Woden Village DA RFI – List of Changes:

SECTION E-E

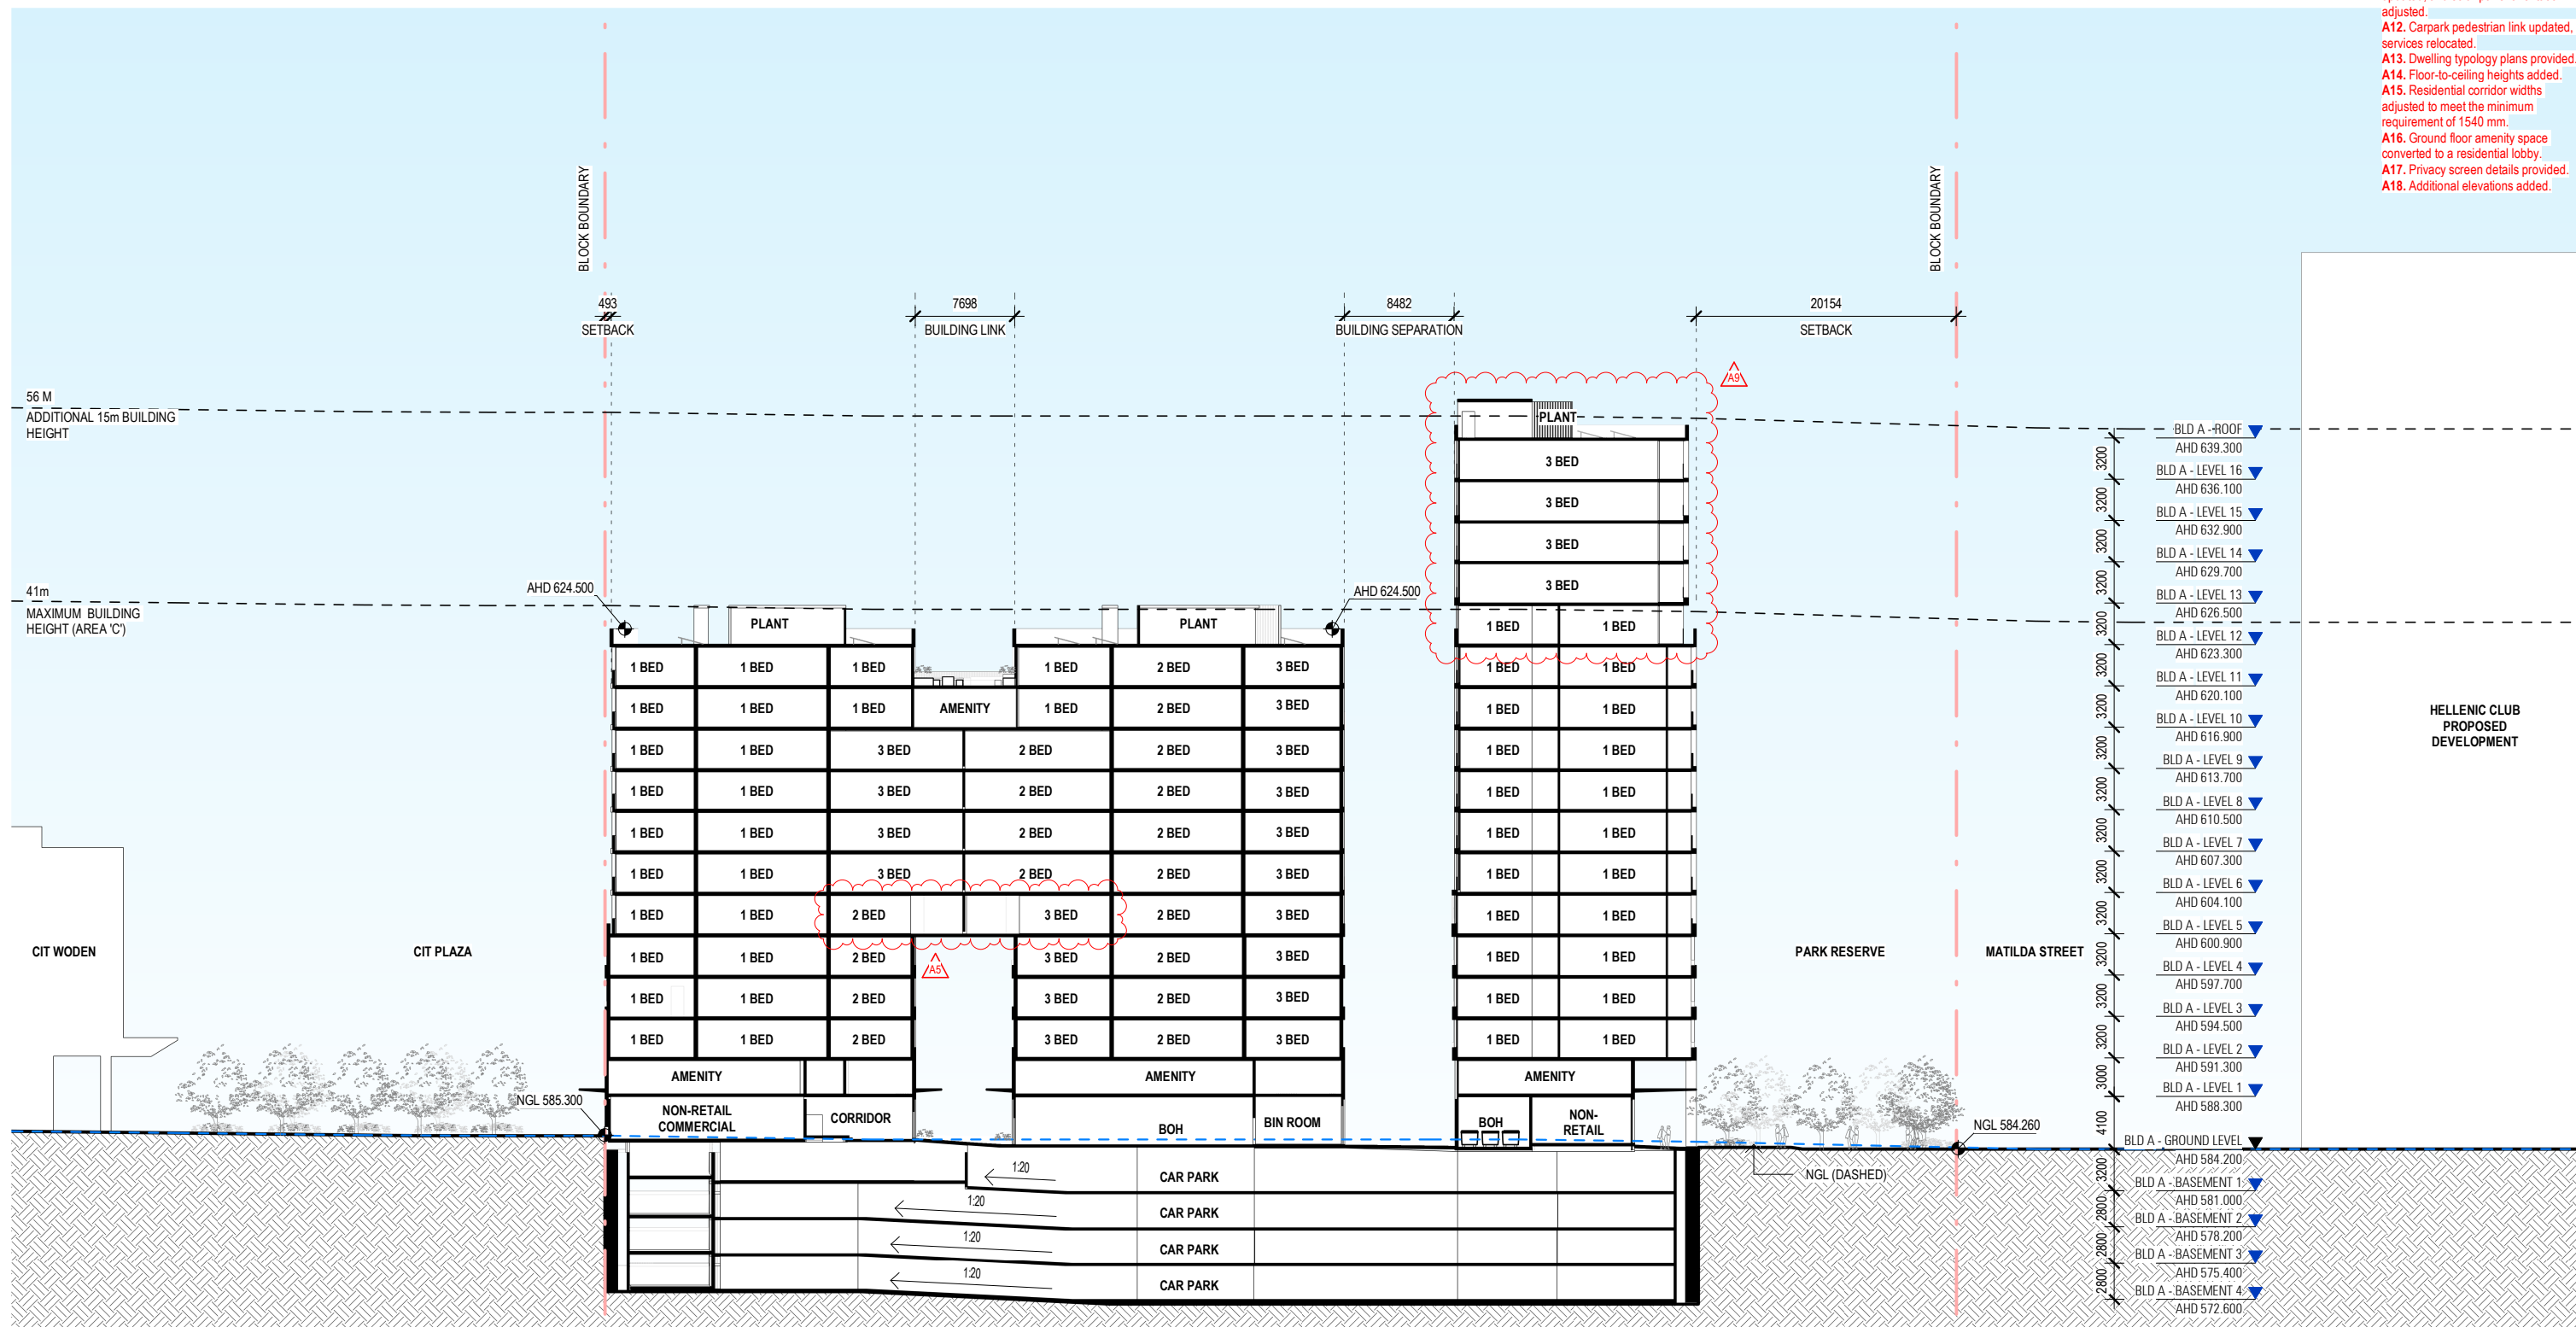
- A1. Driveways and verge crossings updated to match the Waste Management Ground Floor Plan.
- A2. Ground floor waste enclosures and waste storage updated.

- A3. Canopy above the waste collection zone removed.
- A4. Carpark link design revised.
- A5. Residential building link height adjusted.
- A6. Apartment layouts revised to improve functionality.

- A7. Development Schedule for the Community Building revised.
- A9. Northern Residential Tower upper levels revised (façade, internal planning, and apartment mix updated).

- A10. Carpark roof landscape updated.
- A11. Roof plant area setbacks updated, and solar panel orientation adjusted.
- A12. Carpark pedestrian link updated, services relocated.

- A13. Dwelling typology plans provided.
- A14. Floor-to-ceiling heights added.
- A15. Residential corridor widths adjusted to meet the minimum requirement of 1540 mm.

- A16. Ground floor amenity space converted to a residential lobby.
- A17. Privacy screen details provided.
- A18. Additional elevations added.
